# Work Order ID 109878

Item Name: Fwd Crosstube - Low Standard

| DRAWING NO.<br>D212-664-147 | TITLE<br>CROSSTUBE ASS'Y (205 LOW FWD) | REV. B           | DART AEROSPACE LTD<br>ENGINEERING ORDER |  | D.E.O. NO.<br>D212-664-147-B-1 | SHEET NO.<br>SHEET 1 OF 1 | SCALE<br>NTS |

| MFG. APPR. | RF       | D212-664-147  | SHEET 2 OF 4 |

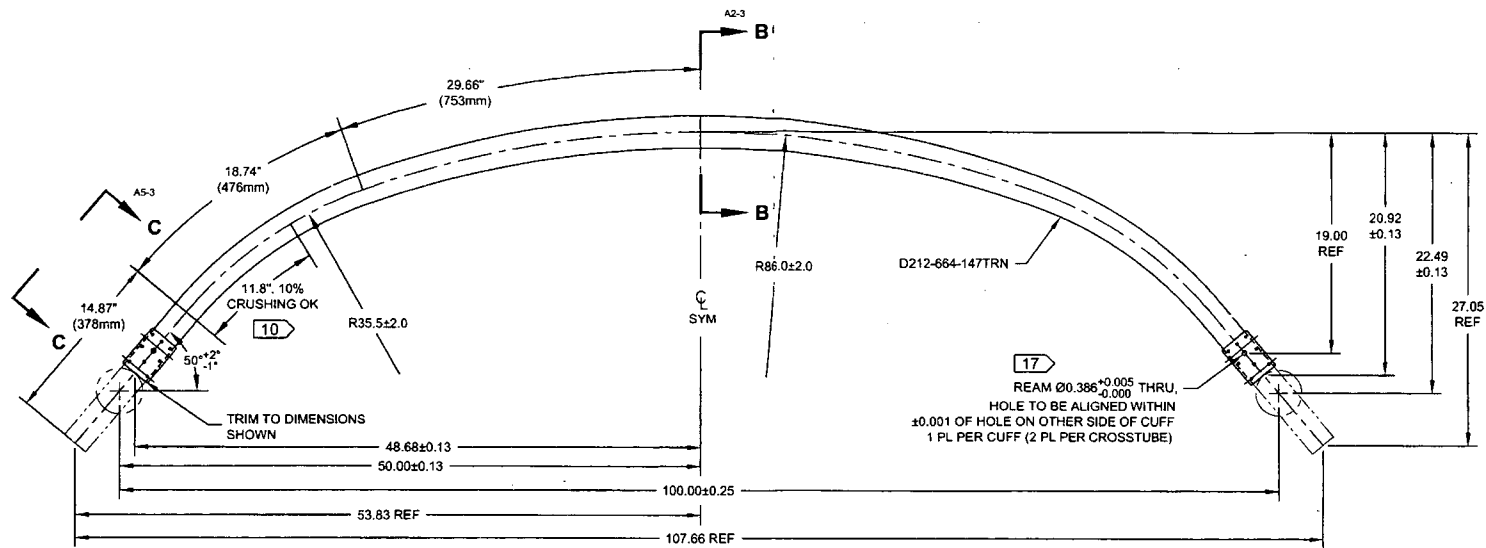
REPLACE MAGNOBOND WITH PROSEAL.

NOTE 12 & 15, SHEET 1 IS AMENDED AS FOLLOWS:

- 12) TO INSTALL D2893-1 SUPPORT: ABRABE MATING SURFACE OF SUPPORT AND CROSSTUBE WITH 180-GRIT SANDPAPER AND REMOVE RESIDUE WITH MEK (OR EQUIVALENT). APPLY A 0.04" TO 0.07" THICK LAYER OF PROSEAL 890 CLASS B-2 (OR AMS-S-8802 CLASS B-2) SEALANT TO MATING SURFACE OF SUPPORT.
- 15) TORQUE CLAMPS 80 TO 100 IN-LB. ENSURE AT LEAST 1.5 THREADS SHOWING IN SAFETY AND THAT NUT HAS NOT BOTTOMED-OUT AFTER TORQUING. PRIOR TO PACKAGING, RE-CHECK TORQUE ON CLAMPS AFTER PROSEAL 890 SEALANT HAS CURED FOR 72 HOURS.
